# Access Compliance Report

## Public Rights-of-Way

Intersection ID: 53270	Main Street: MONROE_RD	Cross Street: MERIDIAN_CENTER_DR	Location: NE
ADA ID: 7D2F41BC72C6	Ramp Type: Directional1	Initial Pass/Fail: Fail	Overall Compliance: No
Severity Score: 12.5			
Codes/Mitigation Info/Possible Solution		Field Measurements/Component Compliance

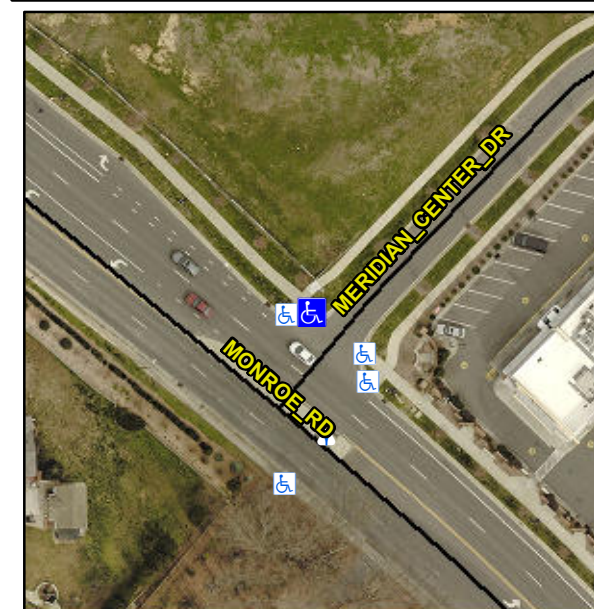
**R304.2.2**

Compliance	Description	Data	Compliance	Description	Data
N/A	Ramp Length (in)	94.0	N/A	Grade Break?	N/A
Yes	Ramp Width (in)	72.0	N/A	Grade Break Slope (%)	0.0
No	Ramp Slope (%)	9.4	N/A	Grade Break XSlope (%)	0.0
Yes	Ramp XSlope (%)	0.1			
N/A	Flare Type LT	N/A	N/A	Flare Type RT	N/A
N/A	Flare Slope LT (%)	N/A	N/A	Flare Slope RT (%)	0.0
N/A	Flare Traversable LT?	N/A	N/A	Flare Traversable RT?	N/A
N/A	Landing Length (in)	0.0	N/A	DWS Provided?	N/A
N/A	Landing Width (in)	0.0	N/A	DWS Contrast?	N/A
N/A	Landing Slope (%)	0.0	N/A	DWS Length (in)	N/A
N/A	Landing X Slope (%)	0.0	N/A	DWS Full Width?	N/A
N/A	Landing Curb? (Y/N)	N/A	N/A	DWS Offset LT (in)	N/A
N/A	Shared Landing?	N/A	N/A	DWS Offset RT (in)	N/A
N/A	Gutter Ponding?	0.0	N/A	Gutter Slope (%)	N/A
N/A	Gutter Lip Ht (in)	0.0	N/A	Gutter X Slope (%)	N/A
N/A	Painted X Walk1?	No		Road Slope (%)	2.6
	X Walk 1 Direction	To E		Road X Slope (%)	0.5
	X Walk 1 Width (in)	N/A		Clear Space?	N/A

**Remove & Replace Entire Ramp.**
